FILE: Engines-Fuel Systems  
Engine Electrical-Cooling  
(POWER PLANT-Engines)  
No. 1-10-82 Sept. 8, 1982

## TECHNICAL BULLETIN

**PROBLEM AND APPLICATION:** The pushrods in some 1981-82 Jeep 258 CID six-cylinder engines built prior to May 1982, may disengage from the rocker arms causing noise, backfire, or a miss.

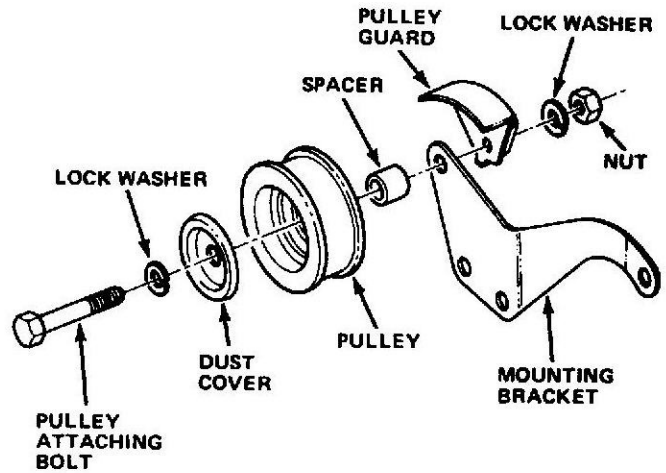
On some 1981 California Jeep Cherokee, Wagoneer, and Truck models built prior to VIN 1JTNA25N5BT015502 and equipped with a six-cylinder engine and air conditioning, the air conditioning back idler pulley or the pulley attaching components may have been installed or assembled incorrectly. This condition could result in a chirp noise from the idler pulley assembly during vehicle acceleration, or whenever engine speed is increased rapidly.

Service correction involves inspecting the back idler pulley components to determine if they have or have not been properly assembled and assembling the pulley components correctly if necessary.

- (1) Inspect idler pulley attaching bolt and note if lock washer has or has not been installed between bolt head and idler pulley dust cover (see illustration).
- (2) Loosen alternator adjusting bolt and release tension on serpentine drive belt.
- (3) Remove nut and lockwasher from idler pulley attaching bolt and remove bolt and pulley components as assembly.
- (4) Carefully disassemble idler pulley components and inspect as follows:
  - (a) Check to see if flat washer was incorrectly installed between idler pulley dust cover and idler pulley. Discard flat washer if a washer was installed.

- (b) Check for idler pulley being installed in reverse position. Deepest counterbore in pulley hub should be facing forward (see illustration). Correct pulley position if necessary.

- (5) Assemble idler pulley, dust cover, spacer, and pulley attaching bolt and lock washer. Refer to illustration for correct assembly sequence. Be sure pulley is correctly positioned and that lockwasher is installed on pulley attaching bolt.
- (6) Position idler pulley assembly on mounting bracket and install lockwasher and nut on pulley attaching bolt. Tighten nut to 36 foot-pounds (49 N·m) torque.
- (7) Adjust serpentine belt tension to 140-160 pounds (623-712 Newtons) force and tighten alternator adjusting bolt to 18 foot-pounds (24 N·m) torque.

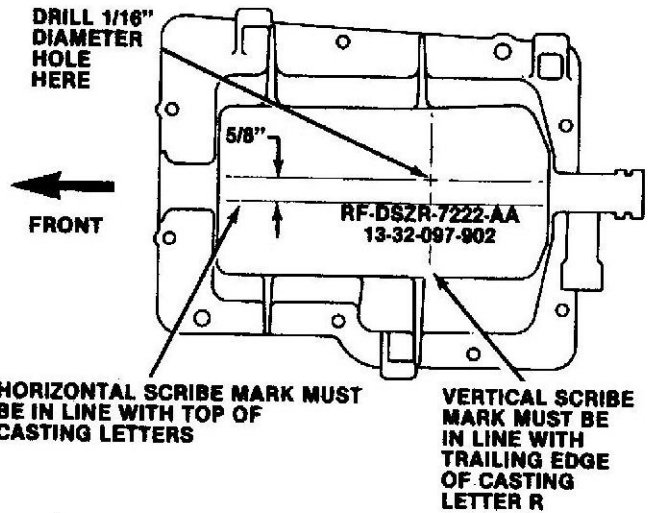
On some 1980-81 CJ and Scrambler models equipped with an SR4 four-speed manual transmission built prior to March 1981, a small amount of transmission lubricant may occasionally escape from the transmission vent located in the transmission adapter. This condition occurs primarily during cold weather warmup and may be caused by the normal increase in working pressure within the transmission during operation.

If inspection indicates that a small amount of lubricant occasionally escapes from the vent, service correction involves drilling a 1/16-inch diameter auxiliary vent hole in the transmission top cover.

- (1) Remove transmission and transfer case shift lever knobs.
- (2) Remove floor carpeting, if equipped.
- (3) Remove screws attaching transmission access cover to floorpan and remove access cover and shift lever boots as assembly.
- (4) Clean transmission top cover surface thoroughly.
- (5) Locate, mark, and centerpunch position of additional vent hole in transmission top cover (see illustration). Scribe vertical mark in line with trailing edge of letter R on casting and be sure horizontal mark is scribed 5/8-inch upward from top edge of casting letters as shown in illustration.

Figure 1 - Throttle Control Rod Spring Position

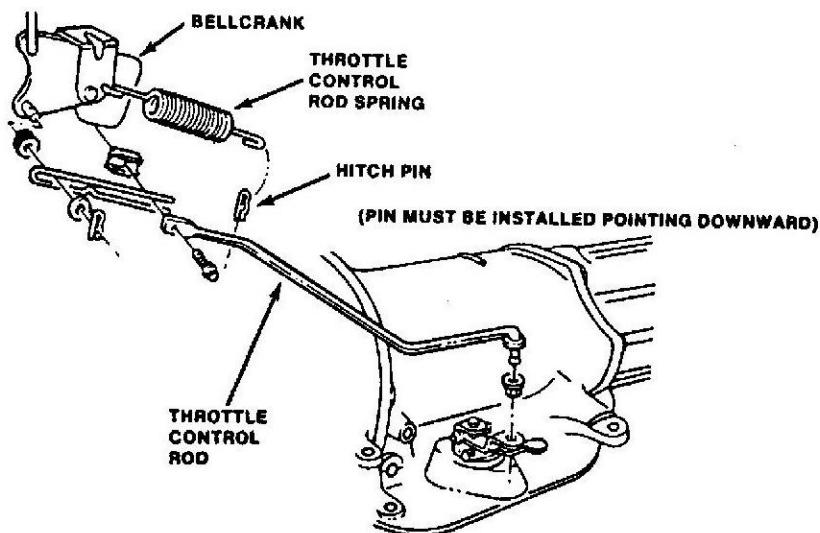
- (1) Open hood and inspect throttle control rod spring position.
- (2) If spring is attached to bellcrank and to hitch pin, as shown in Figure 1, spring is correctly installed. Proceed to Step (4).
- (3) If spring is incorrectly attached at either the bellcrank or the hitch pin, correct, as shown in Figure 1, and check throttle linkage operation.
- (4) Place yellow paint mark on bellcrank to indicate completion of campaign inspection/repair procedure.
- (5) Close hood and return vehicle to owner.

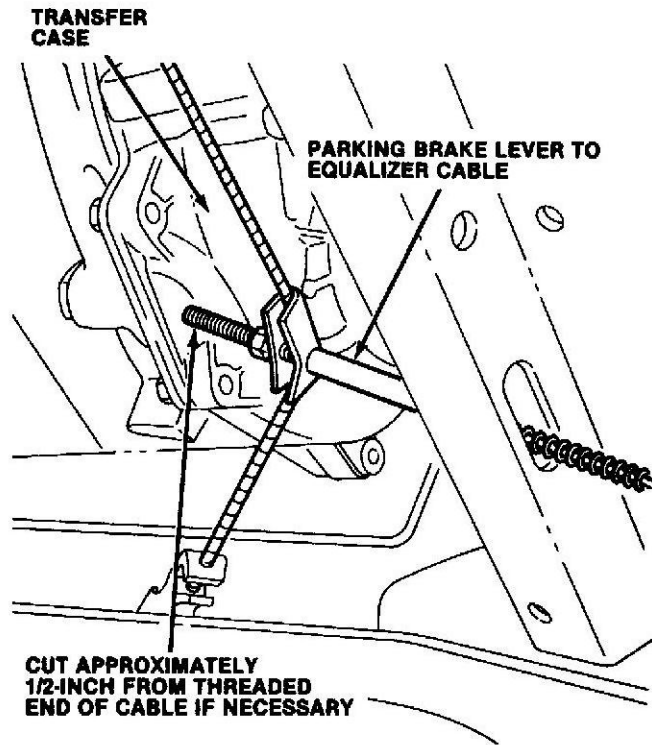
On some 1981 Cherokee, Wagoneer, and Truck models with six-cylinder engine and automatic transmission, the threaded end of the parking brake lever to equalizer cable may contact the transfer case.

Service correction involves inspecting and shortening the threaded end of the cable by approximately 1/2-inch if necessary. This inspection should be performed during any normal service visit.

Fig. 1 — Latch Assembly Inspection

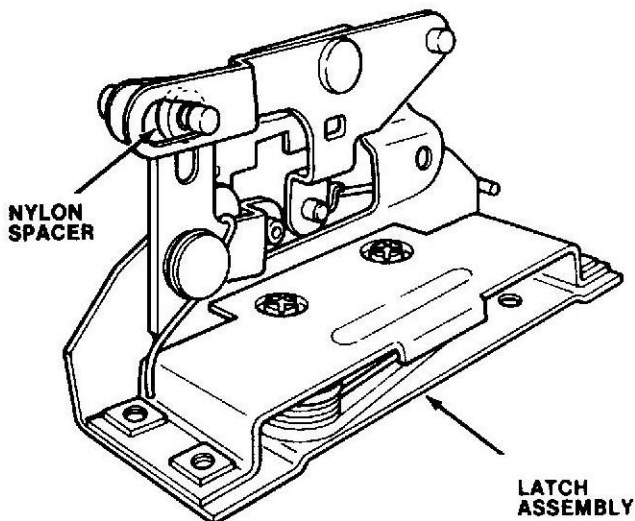
1. Remove the front door window regulator handle, door pull strap, and lower trim panel.
2. Inspect the latch assembly and control rods, and the J-shaped outside door handle rod and bushing.
  - a. Replace the latch assembly if damaged or if the nylon spacer between the lock and release levers, as shown in Figure 1, is damaged or missing.
  - b. If the latch control rod is bent or binding, it must be replaced. Do not attempt to straighten it.
  - c. Inspect the J-shaped outside door handle rod and bushing assembly. If it is bent or damaged, it must also be replaced. The rod must be equipped with a solid-type bushing as shown in Figure 2.

3. Install any necessary replacement components as indicated in the previous inspection step. Refer to the appropriate Jeep Technical Service Manual for procedures.
4. Lubricate the latch mechanism and the outside door handle rod and bushing with Lubriplate or an equivalent lubricant.
5. Roll the front door window down.
6. Remove the remote control handle attaching screw and rock the handle out of the door.

Fig. 3 — Lock Button Pivot Pin Retaining Clip Installation

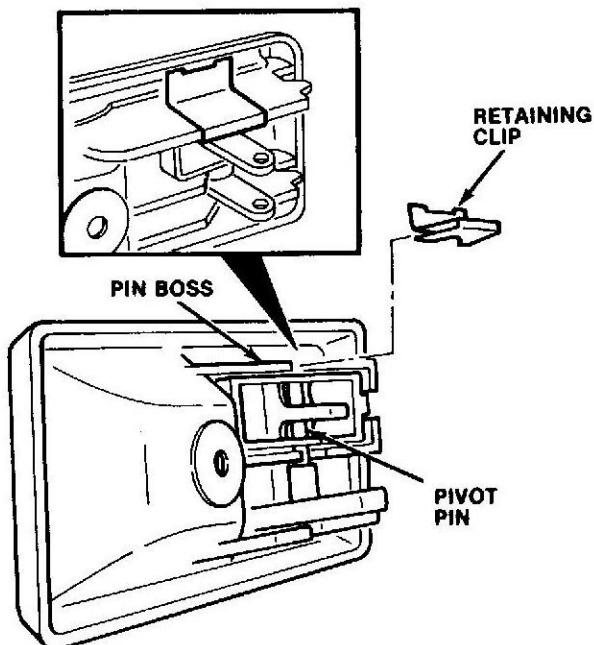
7. Install retaining clip, part number 4007207, over the remote control handle lock button pivot pin and pin boss (Fig. 3). Be sure the clip notch is fully seated on the plastic pin and pin boss.
8. Install the remote control handle in the door and install the handle retaining screw.
9. Install the door lower trim panel, door pull strap, and window regulator handle if not already installed.

**Fig. 1 Positioning Template on Tailgate Inner Panel**

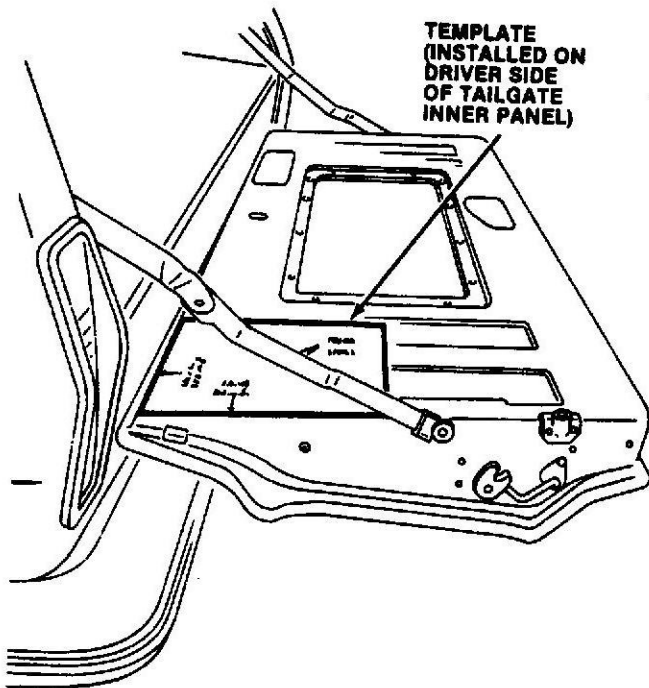
- (9) Drill two 1/4-inch mounting holes for stop bumper brackets at each lower corner of tailgate inner panel as follows:
  - (a) Position right side template on driver side lower corner of tailgate inner panel (Fig. 1). Align template edges with bottom and side of tailgate inner panel, and tape template in place. Mark hole locations indicated on template using centerpunch and remove template.

- (b) Turn template around and position left side template on passenger side lower corner of tailgate inner panel. Align template edges with bottom and side of tailgate inner panel and tape template in place. Mark hole locations indicated on template using centerpunch and remove template.

**Fig. 2 Stop Bumper Installation**

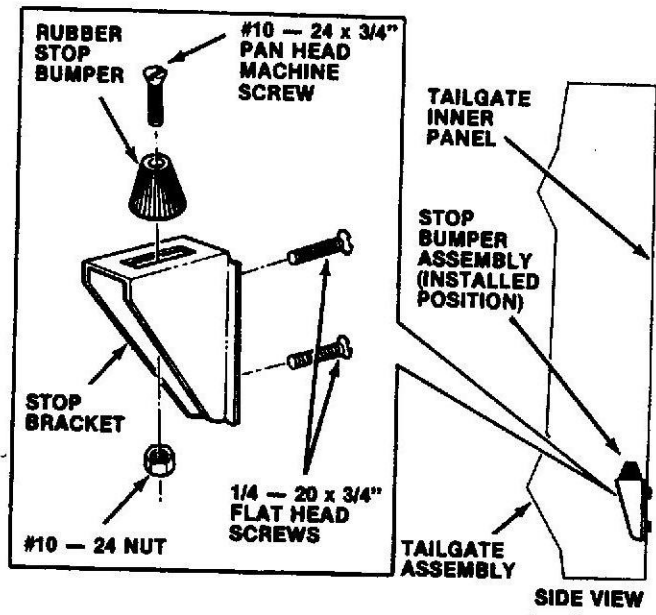
(10) Install rubber bumpers on stop brackets (Fig. 2). Use 10-24 x 3/4-inch pan head screws and nuts to attach bumpers to brackets.

(11) Install one bumper and bracket assembly at each lower corner of tailgate inner panel (Fig. 2). Work through the tailgate access panel opening to install brackets and secure brackets to panel using 1/4-20 flat head screws.

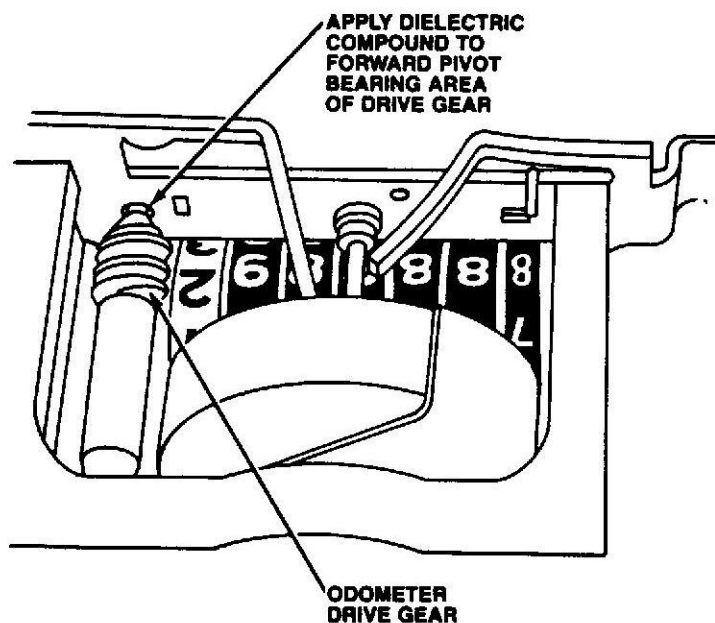
Remove the speedometer/odometer assembly and lubricate the forward pivot bearing area of the odometer drive gear with Dielectric Compound, 8126688 (see illustration).

1. Remove the speedometer/odometer assembly as outlined in Chapter 3C of the 1981-82 Jeep Technical Service Manuals.
2. Apply Dielectric Compound to the forward pivot bearing area of the odometer drive gear as follows: Rotate the odometer driven gear rearward slightly, lift the drive gear upward in its retaining slot, and work the compound into the pivot bearing area (see illustration)

**Fig. 1 Roll Bar Padding Modification**

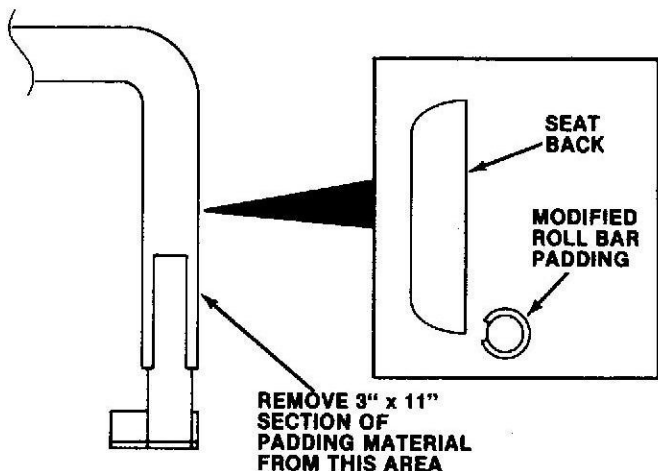
- (1) Move driver seat forward and disconnect storage bag lower strap, if equipped.
- (2) Remove padding cover from roll bar tube at rear of driver side seat back.
- (3) Remove 3-inch x 11-inch section of padding material from contact area using razor blade or sharp knife (Fig. 1).

**Fig. 2 Installing Additional Seat Cushion Frame to Adjusting Slide Spacers**

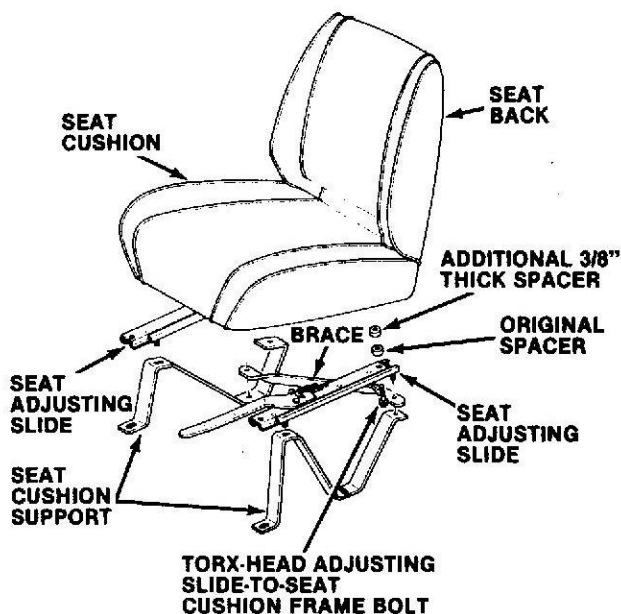
- (b) If contact still exists, proceed to step (6).
- (6) Remove Torx-head bolts that attach rear of seat adjuster slides to seat cushion frame and remove original spacer (Fig. 2). Retain original spacers but discard bolts.

- (8) Lower seat and install longer replacement Torx-head cushion frame-to-seat adjuster slide bolts. Tighten bolts securely. Be sure spacers are properly positioned before tightening bolts.
